# CABINET MEMBER FOR HIGHWAY MANAGEMENT – 14 OCTOBER 2021

# WITNEY – CORN STREET: PROPOSED SHARED USE CYCLE TRACK

Report by Corporate Director, Environment and Place

Annexes Annex 1 Consultation Plans

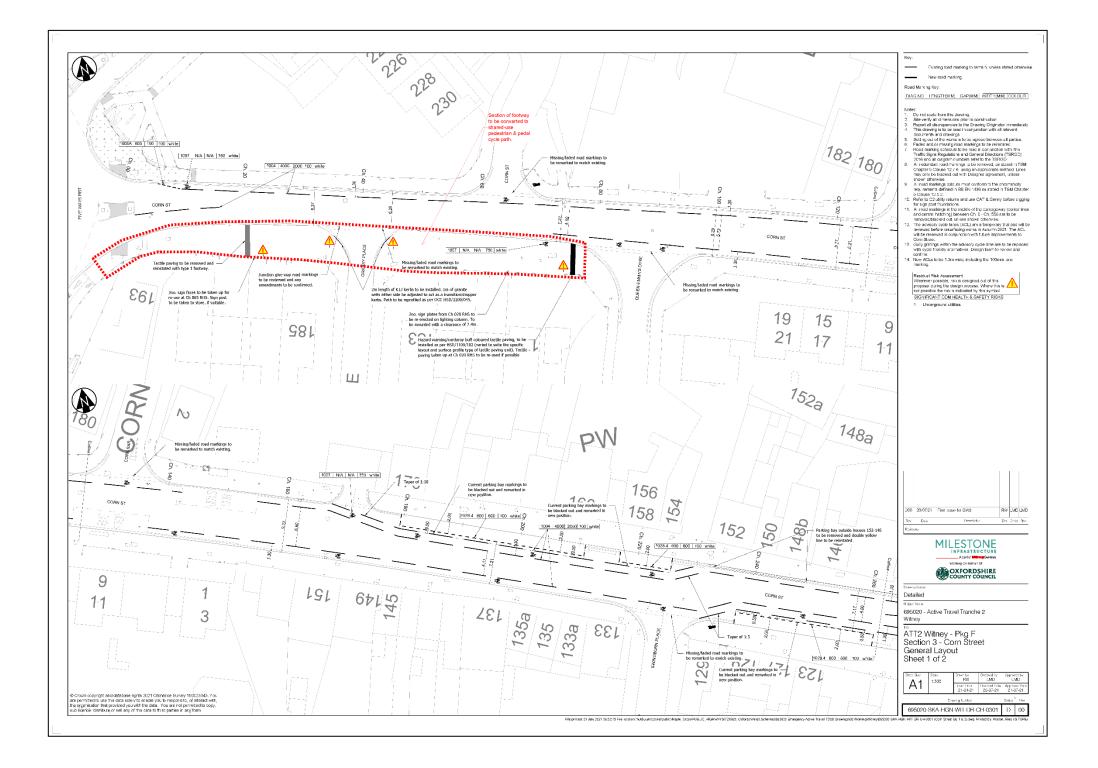
RESPONDENT	COMMENTS
(1) Traffic Management Officer, (Thames Valley Police)	No objection
(2) West Oxfordshire District Council	No objection
(3) Cycling UK Oxfordshire	<ul> <li>Concerns – This scheme will help make the existing cycle provision more joined up and coherent. BUT there are some details that need improving at minimal cost:</li> <li>189 Corn St - Queen Emma's Dyke - footway is wide enough to be segregated use, so should not be shared use. Shared use is the least popular type of provision to users.</li> <li>Side entry treatment for Orkney Place and Queen Emma's Dyke. The cycle/footway should have priority across these turnings (which are no through roads). Give way lines should be provided set back to allow this. As kerbs are being re-laid, the kerb radii should be tightened.</li> <li>More detailed response.</li> <li>The footway width. This is 5 - 5.8m wide (west of Orkney Place) and 5.3 - 6m (Orkney Place - Queen Emma's Dyke, ~4.5m at roundabout sign/litterbin) so why shared use? The existing footway is wide enough to be segregated use from approx the location of the existing tactile slabs (outside no.189) to Queen Enna's Dyke. Just round the corner it is 3.4m segregated use (could be wider if the lamp stand/road sign were moved back), which is much narrower than your proposed shared use provision. I appreciate there needs to be a short section of shared use at the crossing.</li> <li>Relaying lowered kerbs - good</li> <li>Kerb radii. If you are relaying the kerbs, it would be a good opportunity to tighten the kerb radii to slow turning traffic (so benefitting walkers and cycle users). A proper side entry treatment as per LTN 1-20 would be much more preferable.</li> <li>Orkney Place entry - the foot/cycle way should have priority over the ride road exit - so give way lines set back behind the foot/cycle way should be added</li> </ul>

<ul> <li>Queen Emma's Dyke entry - the foot/cycle way should have priority over the ride road exit - so give way lines set back behind the foot/cycle way should be added.</li> <li>Where cycling provision ends. There needs to be some sign/lines/indication that cycling on the footway east of Queen Emma's Dyke is not permitted. Whilst the tactile slabs mark the end of the shared use foot/cycle way, most people's knowledge on the details of such markings is scant, and a lot of people will not connect the textured slabs with the requirement to not cycle on the footway after crossing Queen Emma's Dyke.</li> <li>"End of cycle way" or "Cyclists re-join main carriageway" signs would be appropriate. "Cyclists dismount" signs should NOT be used.</li> <li>On road cycle lane (east bound) outside 172/170 Corn St. The outward taper on the cycle lane markings needs to be more gradual, the outward taper starting closer to the bus stop. This will also have the benefit of moving cycle users. the cycle lane further way from the kerb. This will make cycle users more visible to any drivers turning into the private covered vehicle entrance at 172, so reducing the chance of a left hook.</li> </ul>

(4) Local Resident, (Witney, Corn Street)	Object — I live on Corn Street and have been very concerned for a considerable time re the dangers for pedestrians on the pavement outside my house because of all ready dangers caused by cyclist on the pavement.  What happens to cycling in Corn Street after Emma's Dyke??? There is no sign telling cyclist "go no further "up Corn Street pavement, this was the longstanding problem at the end of Ducklington Lane track it just suddenly stopped so people just cycled around the corner all up Corn Street because there wasn't no a sign or barrier saying not too and became very dangerous especially at the conjunction where the crofts joined Corn Street because of the students from henry box school taking he "backway" down the crofts home very fast round the corner when there were toddlers on the pavement with parents parking their cars going to collect their children from the batts primary school in Corn Street hope this might help in solving an ongoing problem as seen by some local experiencing it regularly

(5) Local Resident, (Witney, Corn Street)	Object – Primarily, who would this benefit? People who live in Queen Emma's Dyke who want to cycle towards Ducklington? As anyone who cycles from Ducklington Lane toward the town centre has to cycle on the road after the proposed new cycle lane ends at Queen Emma's Dyke Entrance.  These Properties have driveway access, which is fine currently when entering to and from the road. However, if you had cyclists, cycling at speed (I used to be able to cycle up to speeds of 30 mph) this could result in more potential accidents. Also, if a child walked out of these Corn street Properties into an oncoming cyclist I dread to think what the outcome could be!  As I am typing this Email about 6 cyclists have cycled past my drive on the footpath. (various ages). Most people

(6) Local Resident, (Witney, Corn Street)	The 'shared' pathway idea proposed at the bottom of Corn Street is neither safe or practical for the reasons described above. The other element that has not been considered is the permanent use of that particular stretch of pathway by parked cars and vans. This has been the case for as long as I have lived in Corn Street, (43years). Sometimes parked vehicles block access to the letterbox so I cannot use it from my wheelchair.
	To allow cyclists to use this part of the pathway is not going to work and I consider it to be very dangerous.
	My suggestion would be to narrow the pavement and widen the road so that a cycle lane could be created. Pedestrians do not mix with cyclists because cyclists do not respect pedestrians especially if they are older and walk slowly or with walking aids. I hope that this ill thought out scheme does not happen.

- 11. Thames Valley Police and West Oxfordshire District Council did not object.
- 12. Cycling UK while agreeing that the scheme will help make the existing cycle provision more joined up and coherent also noted concerns over points of detail which they consider can be addressed at low cost. These suggestions (see Annex 2 for details) are welcomed and will be investigated by the scheme designers.

- 13. Three objections were received from local residents citing concerns over safety of shared use footway/cycle tracks, particularly in respect of child pedestrians and also wheelchair users and the elderly and infirm and the need for the proposals. Some of the responses including suggestions for alternative measures. Noting these comments, experience of shared use cycle tracks in similar environments similar to these proposals has been that they operate with good levels of safety for all road users. However, the scheme designers will also take account of the specific requests for signing included in these responses.
